LAKE HAVASU CITY, ARIZONA ADDENDUM NO. 1

Vadose Well Design and Expansion Project
Project 107015

DATED: August 16, 2023

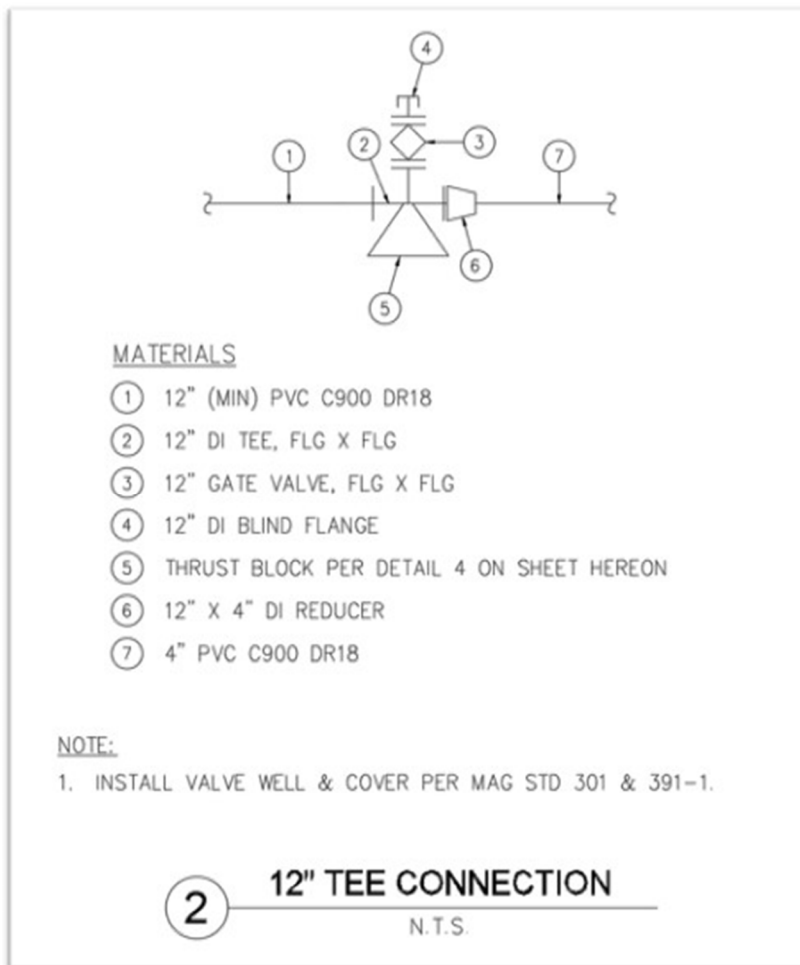
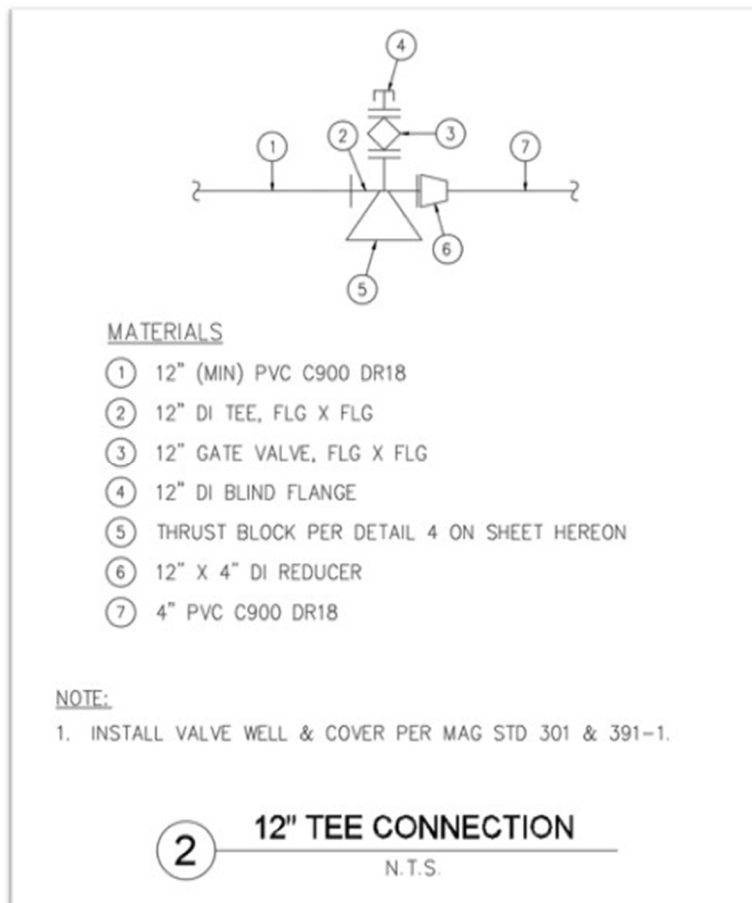
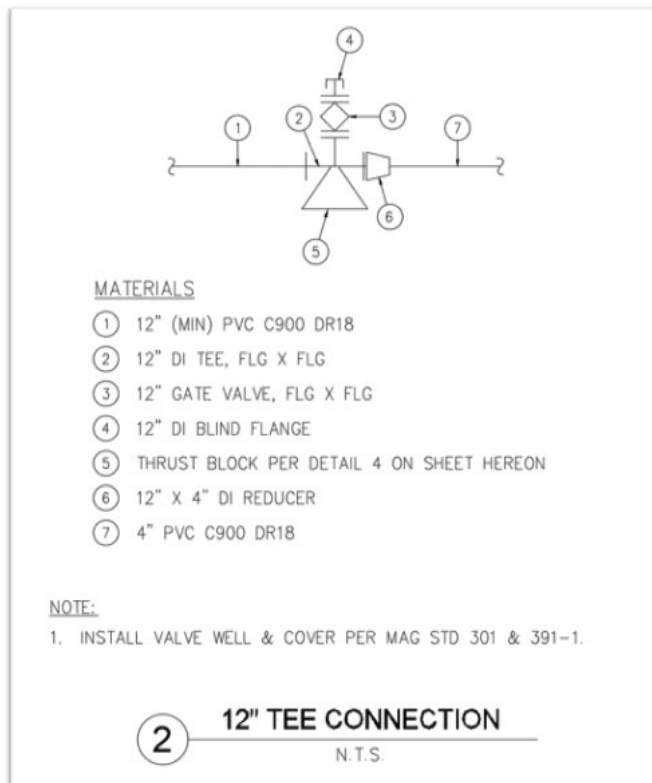
2. **Question:** *"Plan Page 7 indicates 12" SDR 35 on the Profile View. It also indicates DR 14 C900 in Note 2. Plan Page 8 Detail 2 indicates 12" C900 DR18. Plan Page 7: What type of transition is required for the 12" to 4" piping at station 4+33.86? Please Clarify"*

6. **Question:** "Regarding the Tee assembly at sta. 3 + 98.00: Is this a ductile iron fitting and valve? Is MJ x MJ x Flange acceptable vs. the stated PO (push on) x Flange? Also, note the C900 DR18 call out."

11. **Question:** “What point or distance from the well on Sheet M-1 does the 4” Well Discharge line change to 12” size as shown on Sheet C-2?”

Answer: Pipe material shall be 12" PVC C900 DR18. Replace existing Detail No. 2 on Sheet 8, Drawing C-3 with the Revised Detail No. 2 below:

Answer: Replace existing Detail No. 2 on Sheet 8, Drawing C-3 with the Revised Detail No. 2 below. Pipe and fitting material shall be as shown on Detail 2 below:

Answer: Replace existing Detail No. 2 on Sheet 8, Drawing C-3 with the Revised Detail No. 2 below. Pipe and fitting material shall be as shown on Detail 2 below. Detail 2 is referenced on Drawing C-2 as Key Note 9, at STA 3+98.00.
